ADDENDUM NO. 3

Project: Missoula Garden City Compost Improvements Project

Date of Addendum:March 11, 2025Bid Opening Date:Original: March 14, 2025To be amended to March 21, 2025 with this Addendum

Revised Sheet S-3

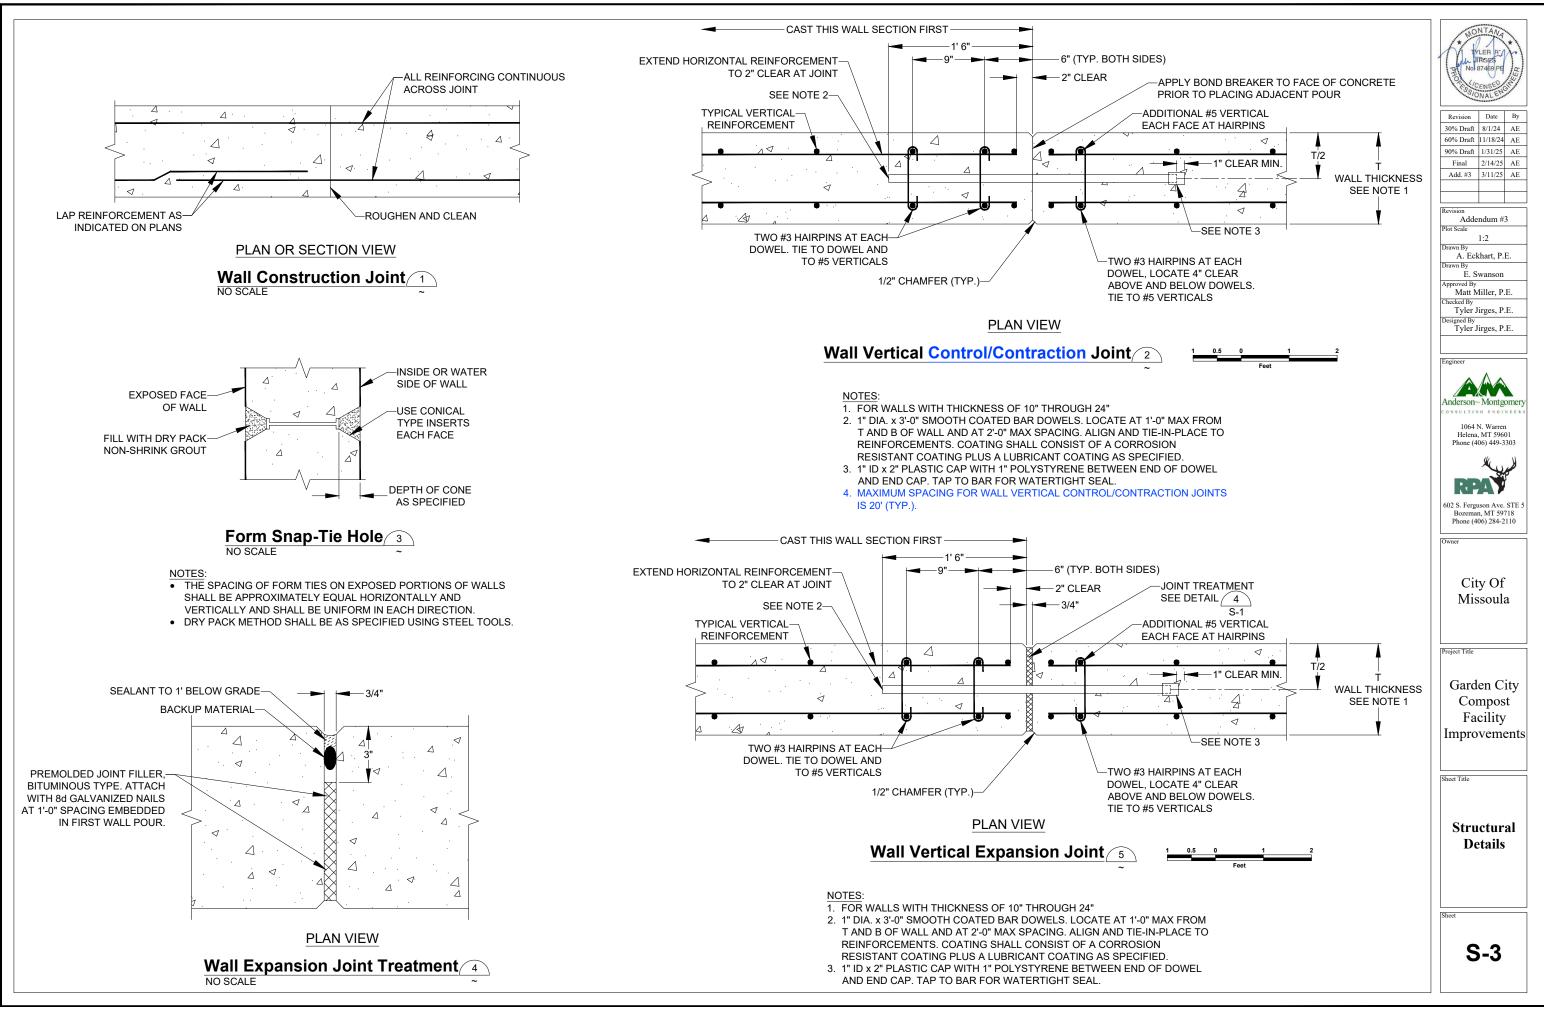
- 1. Sheet S-3 Modifications to Detail 2 providing clarification and maximum spacing of wall vertical Control/Contraction Joints
- 2. Sheet S-10 Modifications to the slab reinforcing steel to be consistent with Sheet S-9:
